ADDENDUM NO. 1

2019 GULF BROOK CHANNEL RESTORATION PROJECT PHASE 2

TOWN OF KEENE – ESSEX COUNTY, NEW YORK

June 27, 2019

DRAWING NO. **S-3** SHT. 21 OF 25
REV. 1

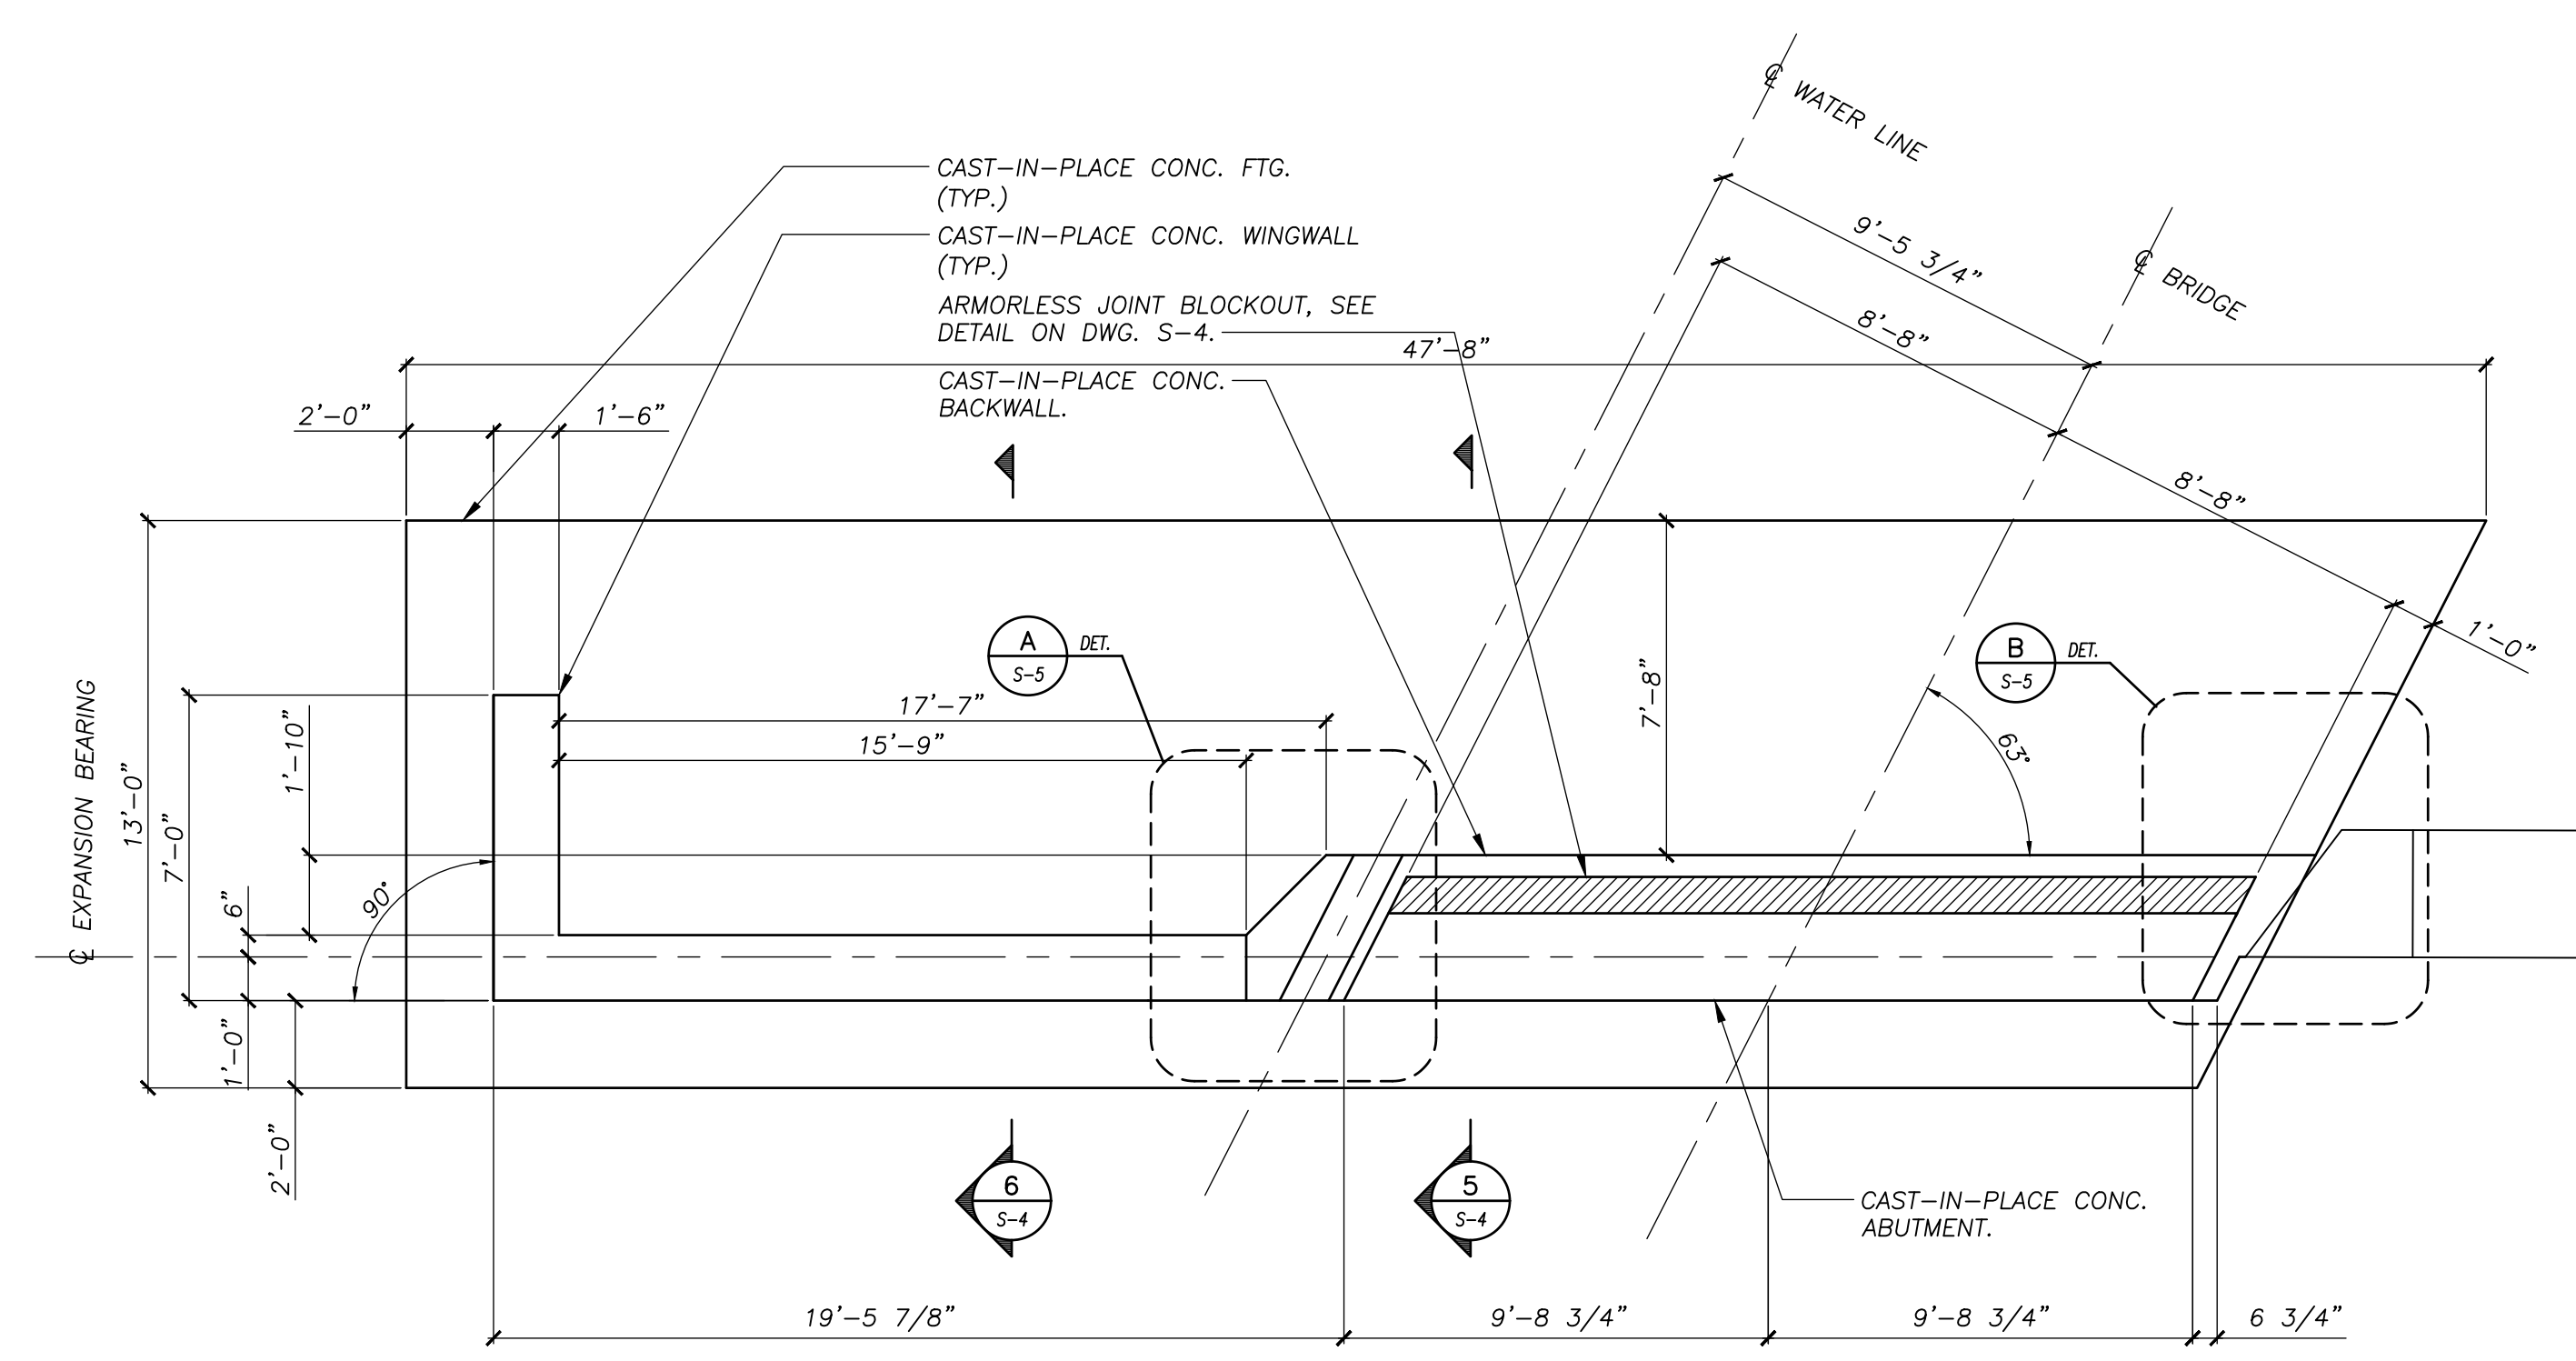
2. **General:** Design plans have been updated and are enclosed and are a part of this Addendum and the Contract Documents. The entire plan set has been updated. Significant changes include the reduction in the overall width of the Bucks Lane Bridge superstructure over Gulf Brook to 17-feet.
